Central Planning Authority

Minutes for a meeting of the Central Planning Authority held on September 16, 2015 at 10:00 a.m. in the Conference Room, 1st Floor, Government Administration Building, Elgin Avenue.

CPA/19/15

Figure 1: An aerial image of the subject parcel with the 2013 (red) and July 2015 (yellow) approximate waterlines indicated and the current registered property boundary (blue) based on the submitted MHW survey taken on 28 Jan 2015 (source: LIS 2013 and DoE 2015).

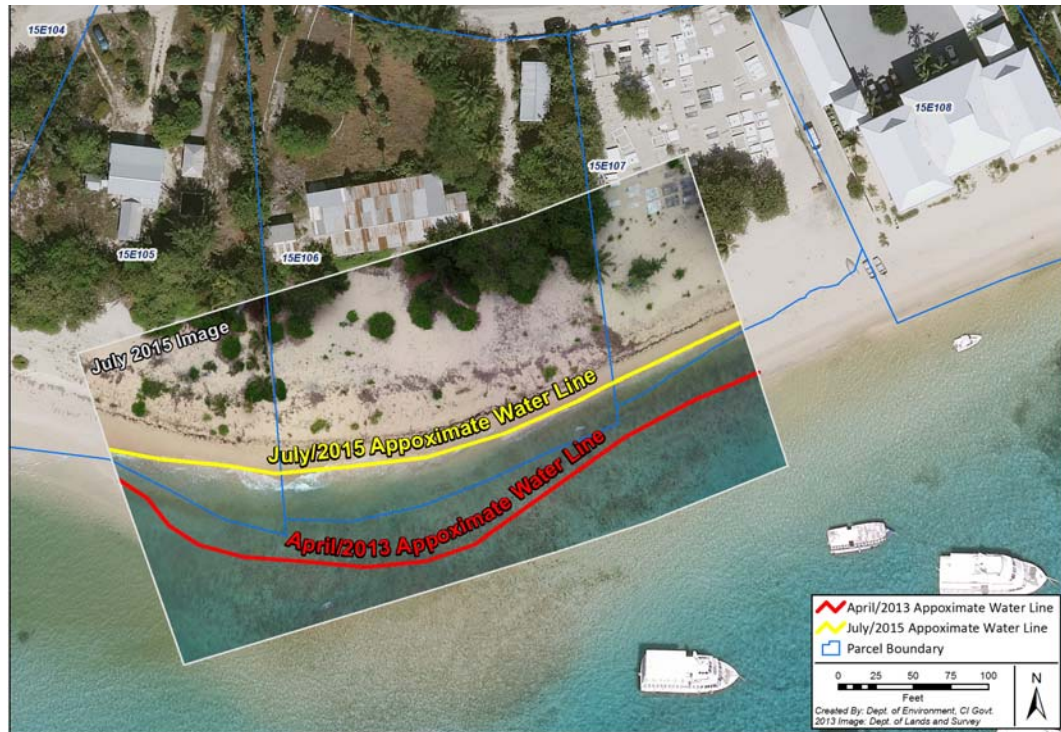
The above referenced parcel forms a critical beach/dune headland transitioning between the north and south coasts of Grand Cayman. Its formation is the result of significant and complex coastal processes that are subject to rapid and continuous changes often leading to large scale fluctuations in the beach profile of this area through erosion and accretion. As is shown in Figure 1 below, in recent years the approximate location of the Mean High Water Mark (MHW) has moved landward significantly.

The DOE's primary concern relates to the building's proposed 75 ft. setback from the currently established MHW, as shown in the submitted plans. A setback of 75 ft. will not likely be adequate for the protection of the property from wave impacts and subsequent beach erosion. Additionally the section of the building footprint from which the minimum setback of 75 ft. is being established (SE corner) is in an area prone to larger fluctuations in beach position (see the following Figures 1-5). The DOE would strongly recommend that, based on historic knowledge and documented evidence of beach movement in this area, the applicants and the CPA should consider a larger setback for the project. An increased setback would allow for the natural beach processes, responsible for maintaining the beach in this area, to remain in vital balance. As has been seen in so many local examples, if built structures such as sea walls, pools or buildings are allowed to directly interact with natural coastal processes (wave action), the complex balance is disrupted and permanent, irreversible beach erosion can occur. This should be a consideration taken into account, not only for the actual building footprint but also any ancillary structures. Additionally building footprints placed well into the active beach system result in the loss of sanddeposits mined for the building foundations and subsequently locked behind seawalls and unavailable to replenish the beach system following major erosion events further compounding erosion problems.

Figure 5: An aerial image of the subject parcel in 2008 (source: LIS 2008).

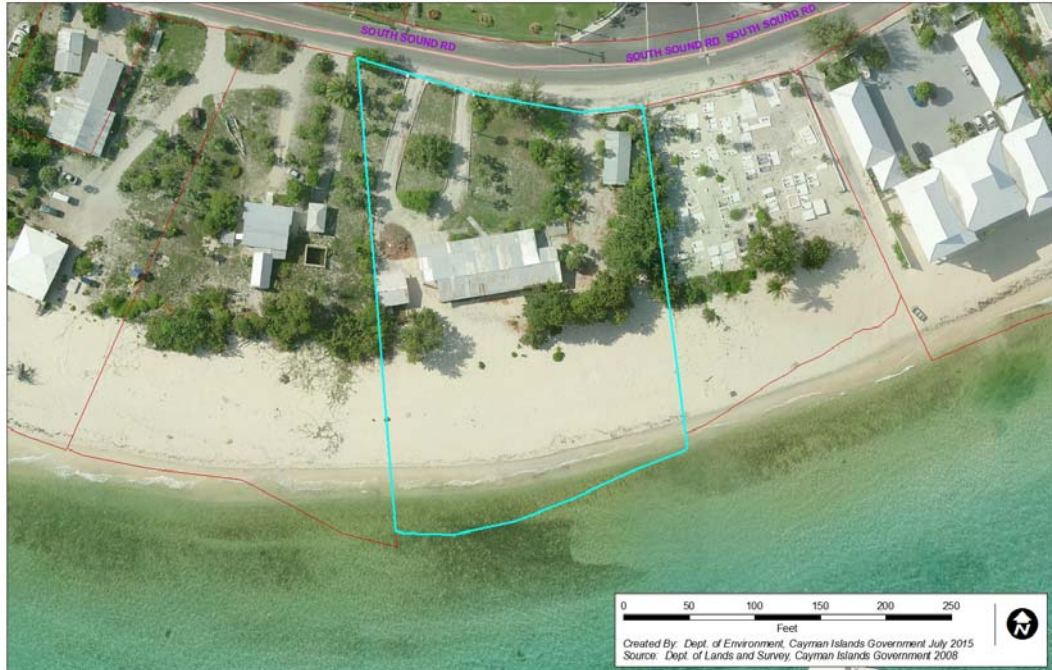
Figures 2-5 are aerial images that show the subject parcel in the years 1994, 2004 (prior to Hurricane Ivan), 2006 and 2008. It is clear from this imagery that the beach profile in this location is dynamic and subject to significant changes. The lack of permanent or significant nearshore vegetation is strong indicator of historic wave conditions in the area and the potential for beach movement.
